APPLICATION FOR A SPECIAL USE PERMIT

APPLICATION #: SUP26-0018
APPLICANT: Kyle D. Tucker, Atty.
OWNER: EDS Investments LLC
ADDRESS: 5825 Angola Road
PARCEL(S): 26-11551
ZONING: Limited Industrial (IL)
NEIGHBORHOOD: South Hill
REPORT DATE: July 31, 2026
HEARING DATE: August 13, 2026
STAFF REVIEWER: Vachon

Details of Special Use Permit Request:

Overall proposed site plan.

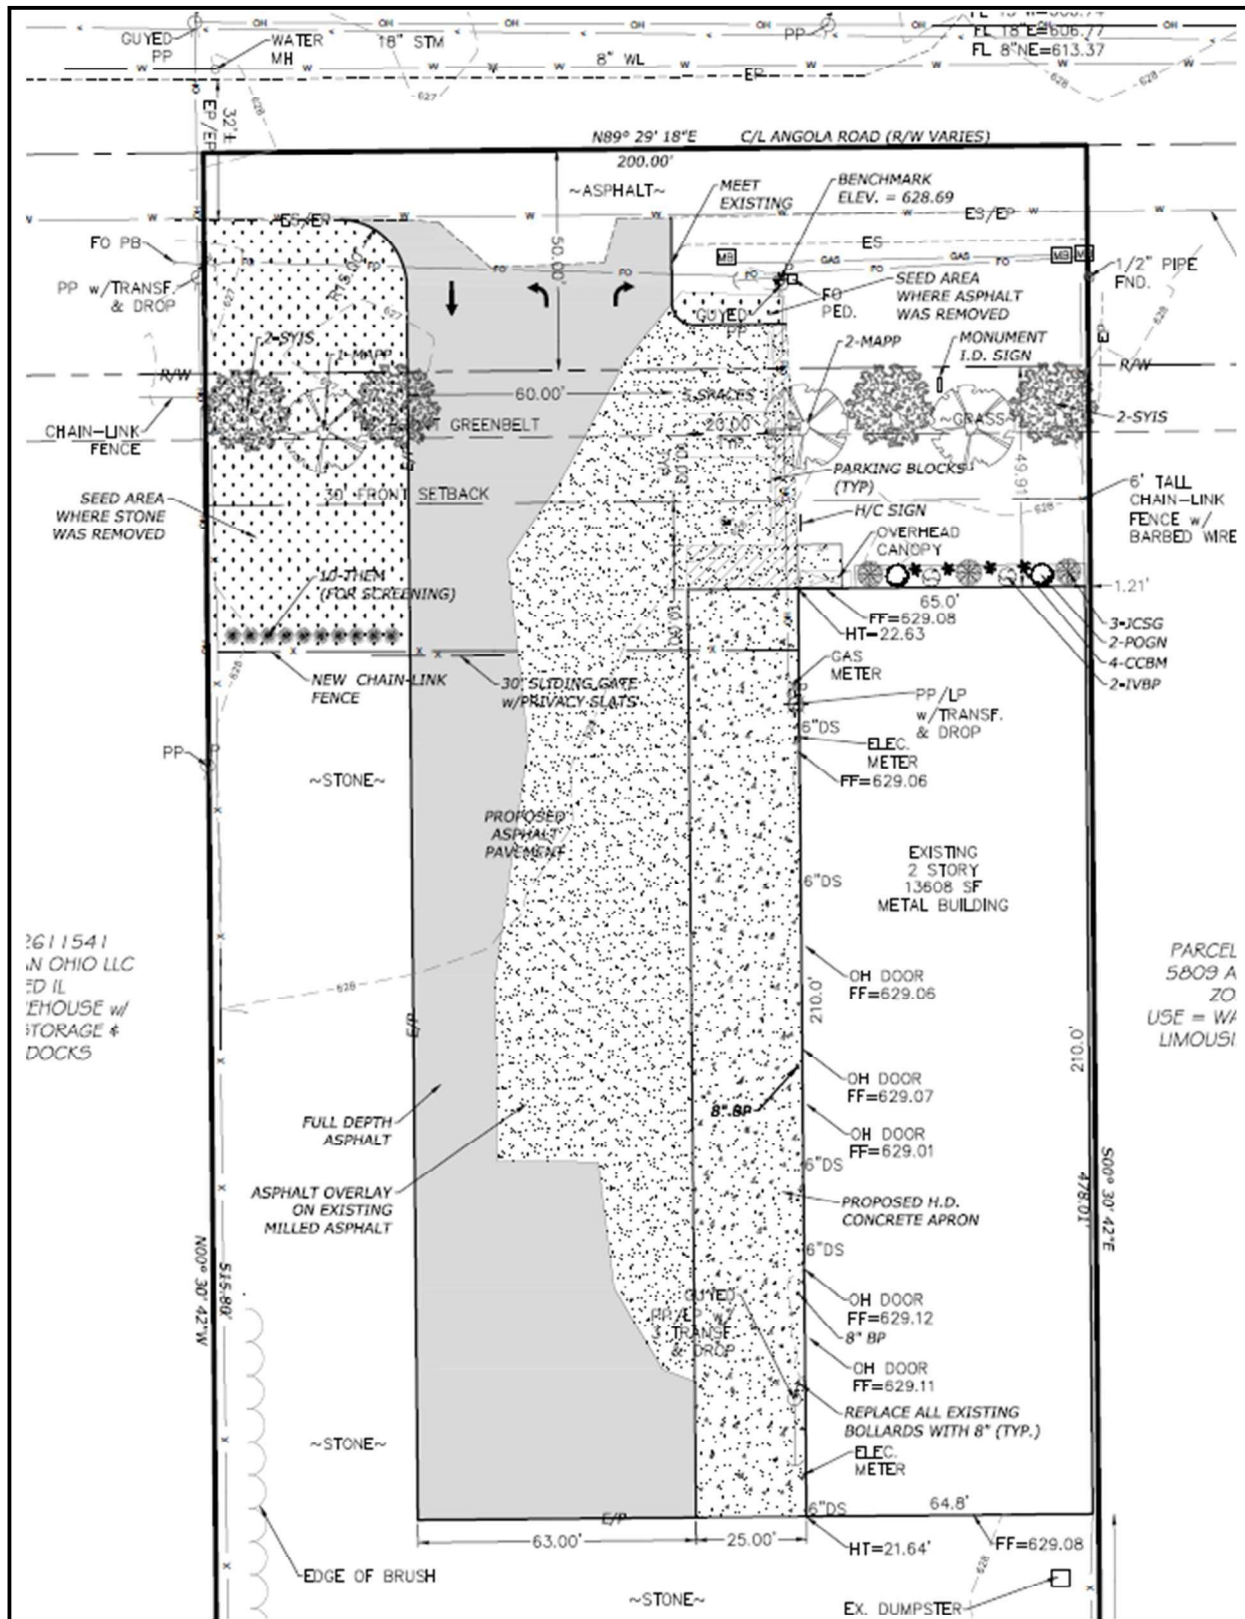
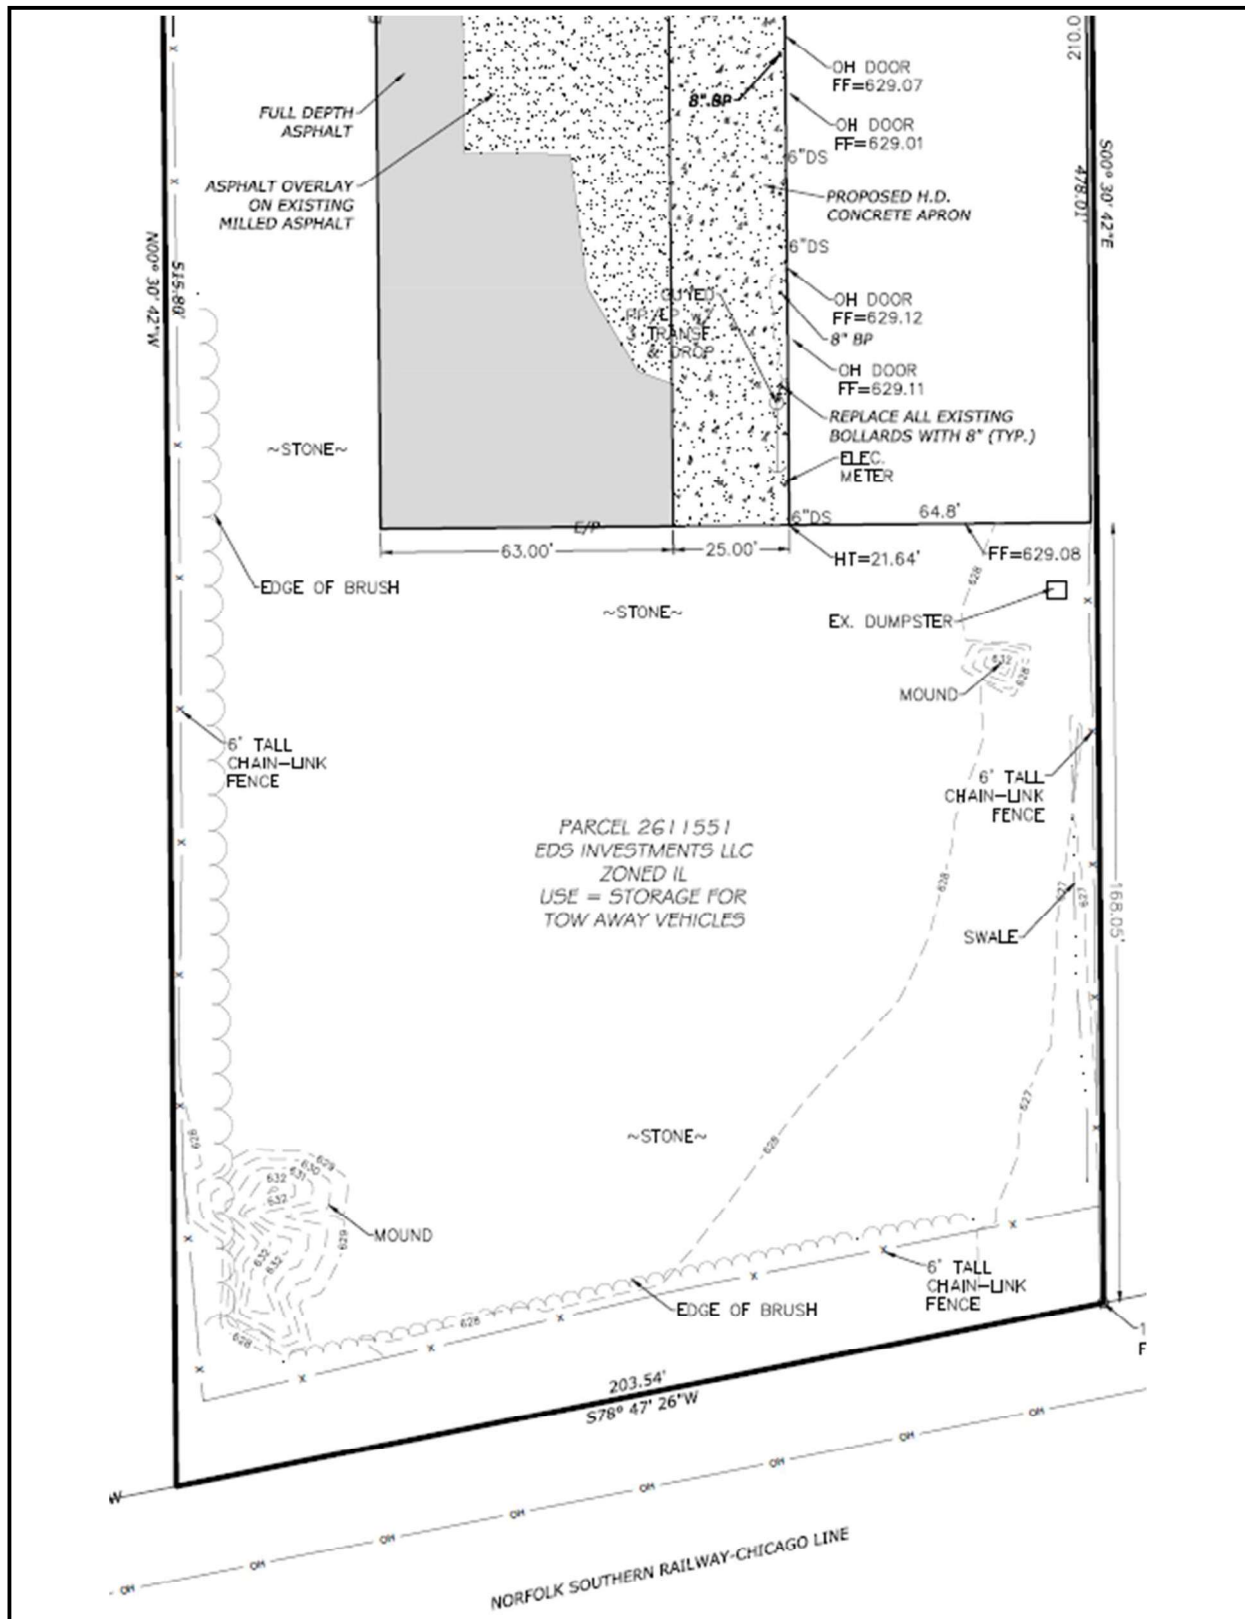
- (a) *Setbacks (1107.1202(B)(1)&(2))*. Off-street parking facilities, including vehicular drives and maneuvering areas are prohibited within required landscape buffers and fifteen feet (15') of the street right-of-way. – Not acceptable as depicted. The site plan proposes five (5) parking spaces north of the building. Three (3) spaces are within the required frontage greenbelt and fifteen feet (15') of the right-of-way. The three (3) spaces shall be removed.

- (b) *Maneuvering Area (1107.1904(A))*. The maneuvering area for a parking space may occur anywhere on a parcel except within any required landscape buffers. – Not acceptable as depicted, through the removal of the northern three (3) parking spaces this code section will be satisfied.
- (c) *Surfacing and Drainage (1107.1906)*. Off-street parking and loading spaces, parking lots, maneuvering areas, aisles and driveways shall be surfaced with concrete, bituminous asphalt, or other dust-free material other than gravel or loose fill. – Not acceptable as depicted, a waiver of this code section is requested.

- (a) *Frontage Greenbelt (1108.0202)*. If a parking lot is proposed to be developed in the front of the property, the frontage greenbelt shall include a solid evergreen hedge planting to screen the parking lot so that no headlights of any vehicles can be seen from the street. – Not acceptable as depicted, a solid evergreen hedge planting shall be provided adjacent to the parking spaces in front of the building.
- (b) *Outdoor Storage Screening (1108.0203(H))*. Fencing six feet (6') to ten feet (10') in height is required to screen outdoor storage. The fence type may be shadow box, chain link with slats, or stockade – The site plan depicts a six foot (6') tall fence surrounding the perimeter of the site. The perimeter fencing shall have slats to fully screen all outdoor storage.

22. Per TMC§1107.1202(B)(1)&(2), off-street parking facilities, including vehicular drives and maneuvering areas are prohibited within required landscape buffers and fifteen feet (15') of the street right-of-way. Three (3) parking spaces proposed in required setbacks north of the building shall be removed and shown on a revised site plan.

23. A solid evergreen hedge planting shall be provided adjacent to the parking spaces north of the building and depicted on a revised site plan.
24. The six-foot (6') tall fence surrounding the perimeter of the site shall have slats to fully screen all outdoor storage.
